Docket Number(s)	<u>50-269, 50-270, AND 50-287</u>
Plant/Facility Name	<u>OCONEE NUCLEAR STATION, UNITS 1, 2, AND 3</u>
TAC Number(s) (if available)	<u>MB5361, MB5362, AND MB5363</u>
Reference Meeting Notice	<u>MARCH 6, 2003</u>
Purpose of Meeting (copy from meeting notice)	<u>TO DISCUSS JUNE 7, 2002, SUBMITTAL ON</u> <u>TORNADO MITIGATION</u>

*Oconee Nuclear Station
Tornado License Amendment
Request Meeting*

DUKE RESPONSES TO RAI CONCERNING PROPOSED LICENSE AMENDMENT REQUEST TO FULLY CREDIT THE STANDBY SHUTDOWN FACILITY AND TO ELIMINATE CREDITING THE SPENT FUEL POOL TO HIGH PRESSURE INJECTION SYSTEM FLOW PATH FOR TORNADO MITIGATION, OCONEE NUCLEAR STATION, UNITS 1, 2 AND 3

Figure 1 - Distribution of Tornadoes by Month and Intensity

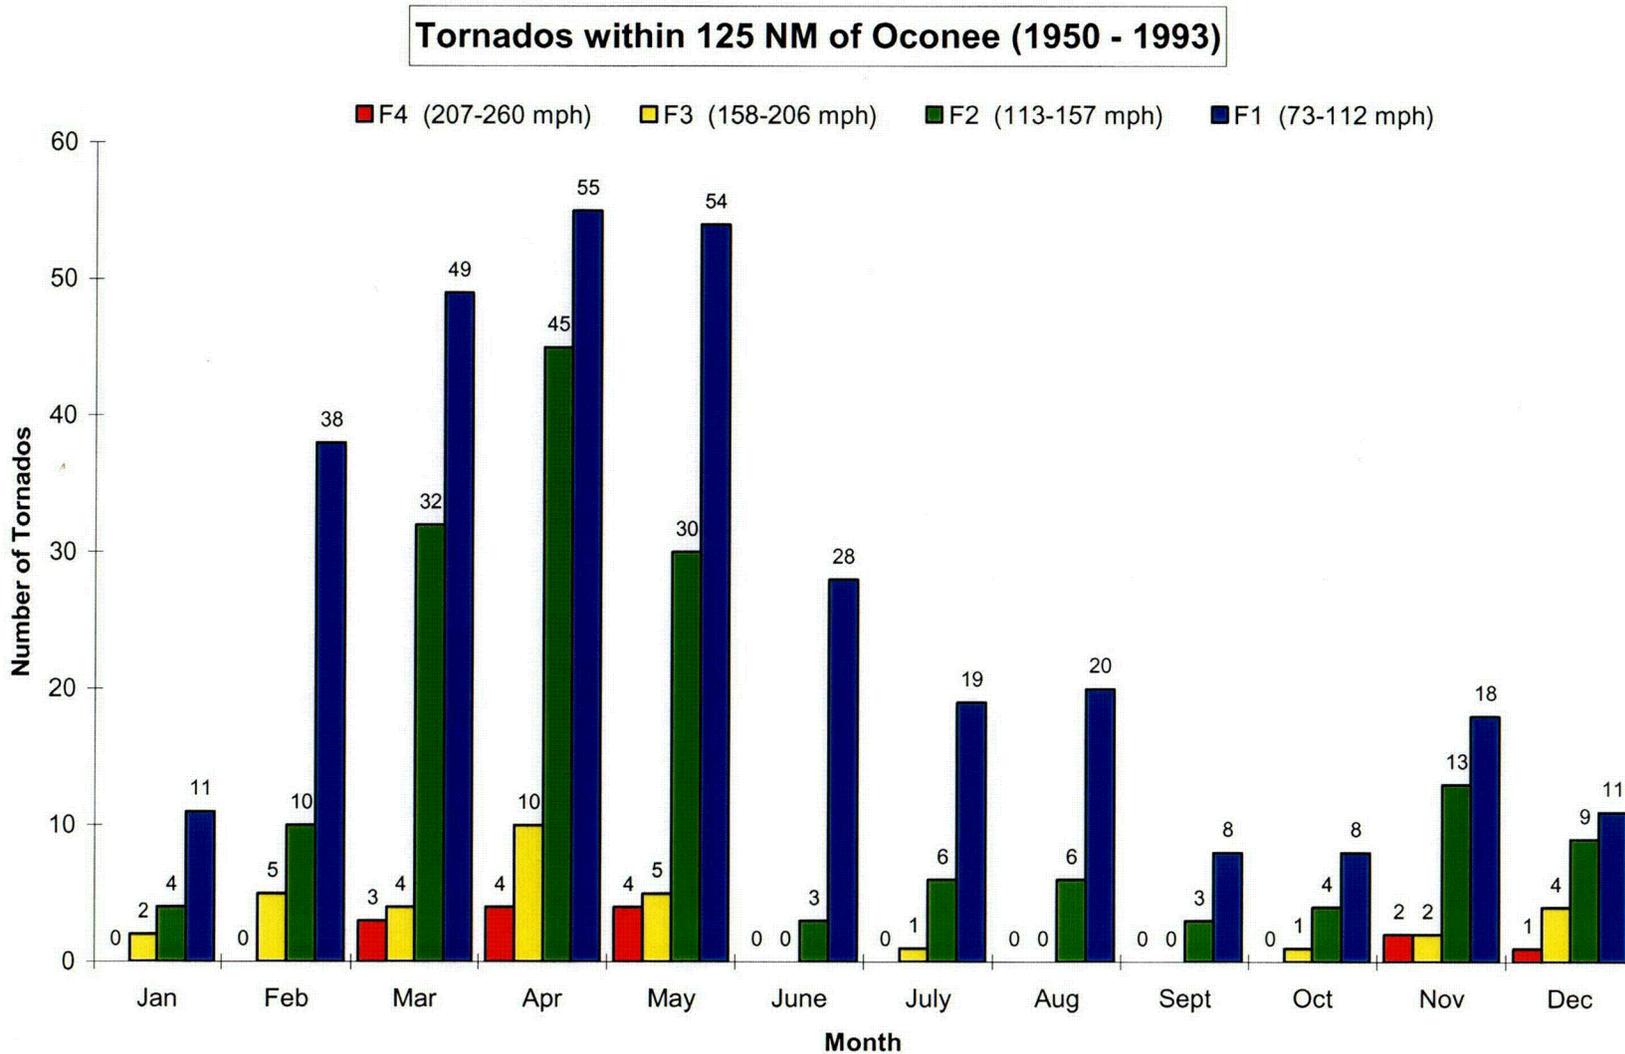
- d. Provide a graph that shows the probability of tornado occurrence at the Oconee Station vs. Time of Year, and explain how operability of the SSF will be assured and maintained during periods when the probability of tornado occurrence is relatively high.

Figure 1 provides a graph of the seasonal distribution of tornado occurrences for the region surrounding the Oconee site. This graph clearly shows that the months of March, April, and May have a significantly higher occurrence rate and a higher number of high-intensity (F-3 and F-4) tornadoes. The equivalent tornado strike frequency during these months is roughly twice the average annual strike frequency.
